Technical Service Bulletin

TBJ002D

Product: ATP32U01, ATP32U02 & ATA32U01 thermostats in conjunction with units using auxiliary electric heat.

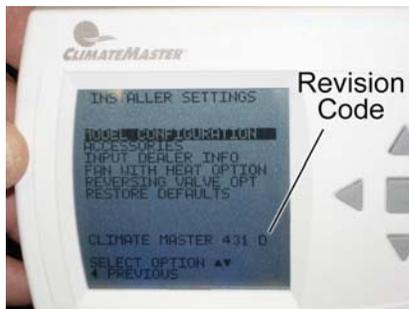
Issue: Auxiliary electric heat will not function unless used with the optional outdoor sensor (AST008). During temperatures that require auxiliary electric heat, thermostat set point will not be achieved. The emergency electric heat mode does function properly as does electric heat during a “lock out” mode.

Effected Range: Uninstalled thermostats can be checked by the date code and/or part number. The thermostat’s box label (shown lower right) lists the part number and date code (first 2 digits indicate week, last 2 digits indicate year). Return any thermostat with date code of **3506** or before without the part number highlighted in yellow. Correctly programmed thermostats have either a date code of **3606** or later or any date code with the part number highlighted in yellow. Example would be of lower right picture; even though date code is before 3506, the part number is highlighted in yellow indicating this thermostat has the correct program. Installed thermostats should be checked by the revision codes (shown in lower left picture). Compare revision codes to the chart listed below.

Solution: Affected thermostats must be replaced and returned to ClimateMaster. Replacement thermostats must be ordered through the Business Center, credit will be issued upon receipt of returned thermostats to ClimateMaster. Request a Return Authorization in the comment section of the order.
